Model: Bellini Finisher		Date: 31-May-00	No.: MB302001
Modified Article: Timing Pulley - 28Z		Prepared by: H.K.	
From: Technical Services Dept., GTS Division			
Reason for Modification:	☐ Parts catalog correction ☐ To facilitate assembly ☐ Part standardization	☐ Vendor change ☐ To improve reliability ☒ Other	☐ To meet standards ()

RCL (Japan) Production

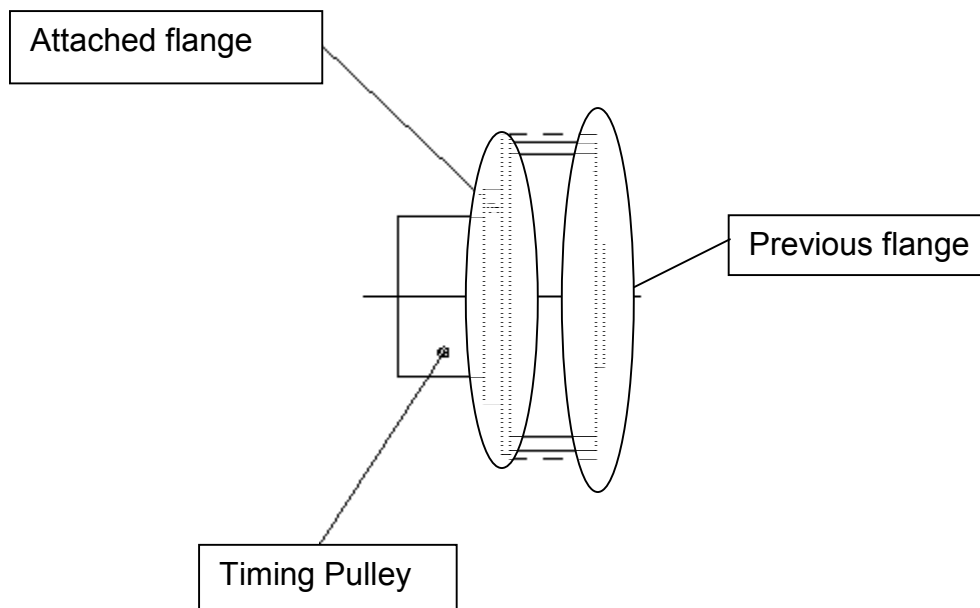
To ensure proper rotation of the shift tray sponge roller timing belt, one flange has been attached to either side of the pulley. Previously, there was only one flange.

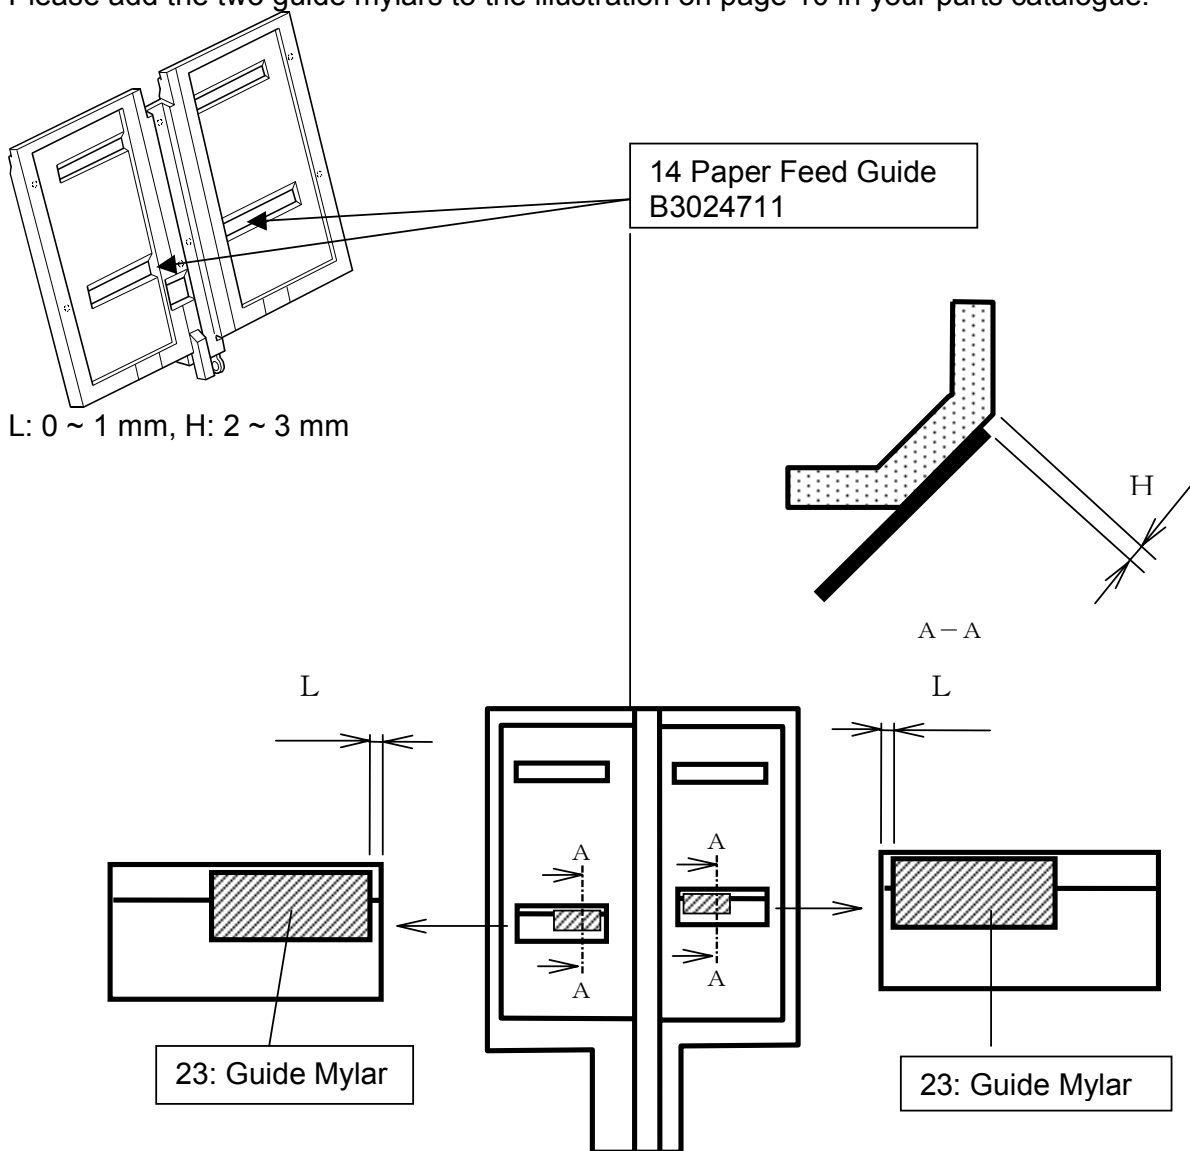
Please add the following part to your parts catalogue.

Please add the two guide mylars to the illustration on page 10 in your parts catalogue.

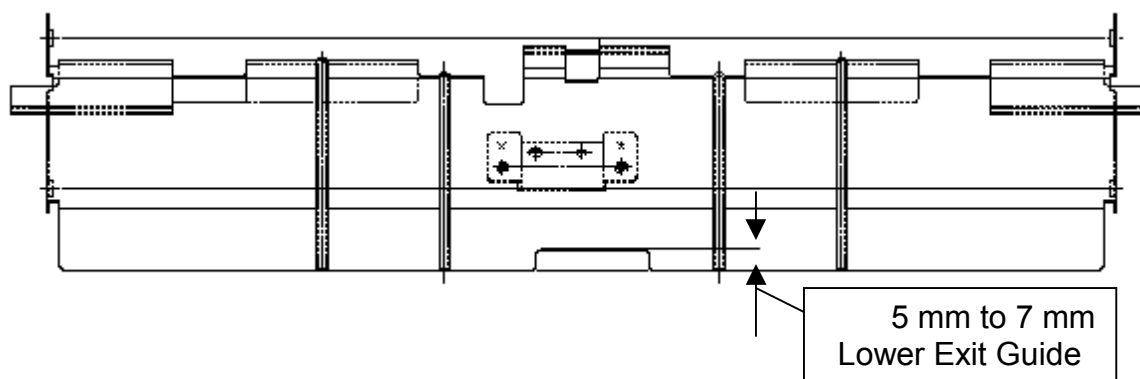
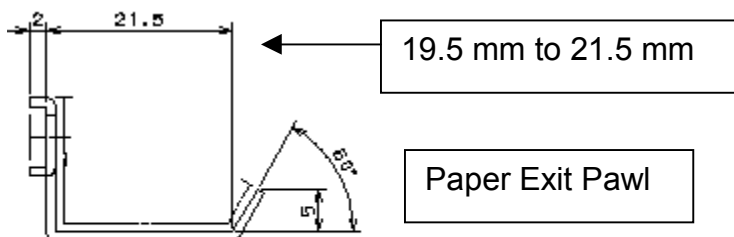
To improve stacking in the jogger unit, the production machines have been modified as follows:

1. The widths of the positioning fences (Front, Middle, and Rear) have been modified as follows:

Note 1: When replacing either of the old fences in the field, install all three new parts as a set.

2. In addition to the widened three positioning fences, the shapes of the paper exit pawl and lower exit guide have been changed to improve transporting stapled copies.

Note 2: When replacing either of the old parts in the field, install both new parts as a set.

Right Guide – Vertical Transport

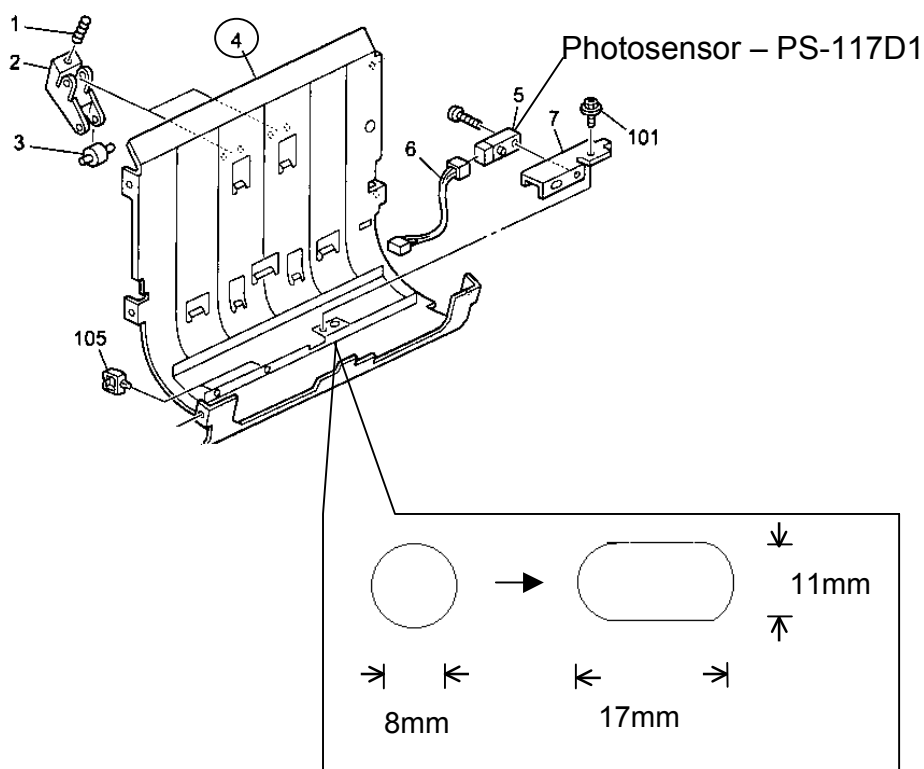
The size and shape of the photosensor window on the vertical transport right guide has been changed from 8 mm round to 11x17 mm square.
This is to prevent the sensor from malfunctioning because of punch waste.

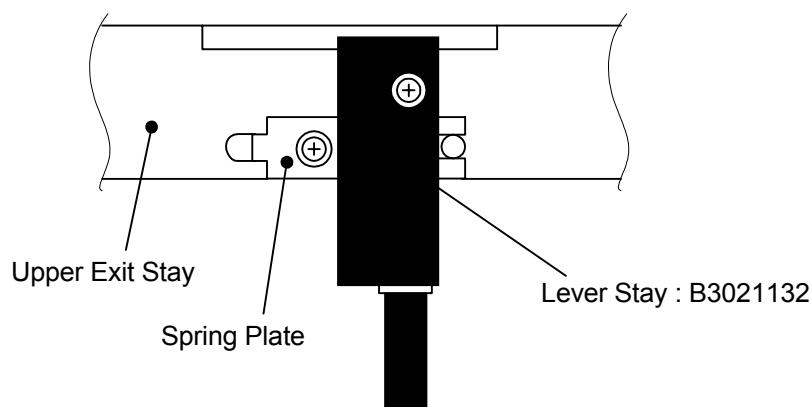
1: These parts should be replaced at the same time.

To improve the reliability of the spring plate and prevent any deformation, a lever stay has been added to the upper exit stay as shown below.
